Access Compliance Report

Public Rights-of-Way

(Curb Ramps)

Intersection ID: 19730	Main Street: SOUTH_PARK_DR	Cross Street: MORRISON BV	Location: NW
ADA ID: 8F29FD49E3ED	Ramp Type: Perp	Initial Pass/Fail: Fail	Overall Compliance: No
Severity Score: 33.75			
Codes/Mitigation Info/Possible Solution		Field Measurements/Component Compliance

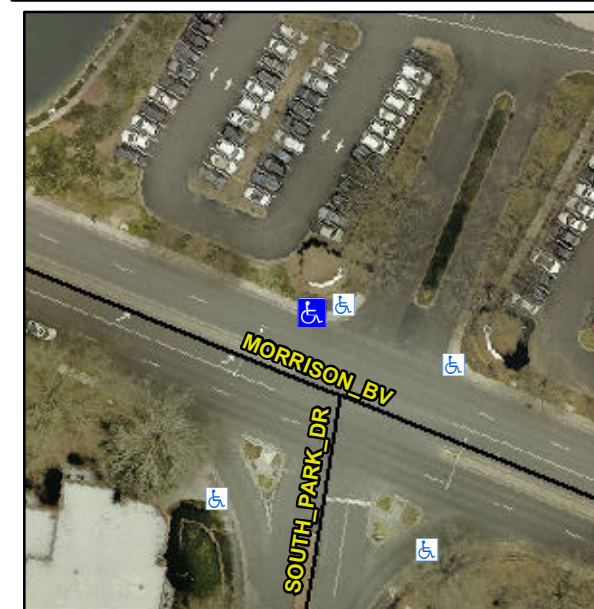
Not Found, R304.5.1, R304.2.2, R304.5.3

Compliance	Description	Data	Compliance	Description	Data
N/A	Ramp Length (in)	46.0	No	Ramp Slope (%)	9.2
No	Ramp Width (in)	47.0	No	Ramp XSlope (%)	5.5
N/A	Flare Type LT	N/A	N/A	Flare Type RT	N/A
N/A	Flare Slope LT (%)	N/A	N/A	Flare Slope RT (%)	N/A
N/A	Flare Traversable LT?	N/A	N/A	Flare Traversable RT?	N/A
N/A	Landing Length (in)	N/A	N/A	DWS Provided?	N/A
N/A	Landing Width (in)	N/A	N/A	DWS Contrast?	N/A
N/A	Landing Slope (%)	N/A	N/A	DWS Length (in)	N/A
N/A	Landing X Slope (%)	N/A	N/A	DWS Full Width?	N/A
N/A	Landing Curb? (Y/N)	N/A	N/A	DWS Offset (in)	N/A
N/A	Shared Landing?	N/A			
N/A	Gutter Ponding?	N/A	N/A	Gutter Slope (%)	N/A
N/A	Gutter Lip Ht (in)	N/A	N/A	Gutter X Slope (%)	N/A
N/A	Painted X Walk1?	No	N/A	Painted X Walk2?	N/A
	X Walk 1 Direction	To S		X Walk 2 Direction	N/A
N/A	X Walk 1 Width (in)	N/A	N/A	X Walk 2 Width (in)	N/A
	X Walk 1 Slope (%)	1.8		X Walk 2 Slope (%)	N/A
	X Walk 1 X Slope (%)	4.5		X Walk 2 X Slope (%)	N/A

Remove & Replace Entire Ramp.
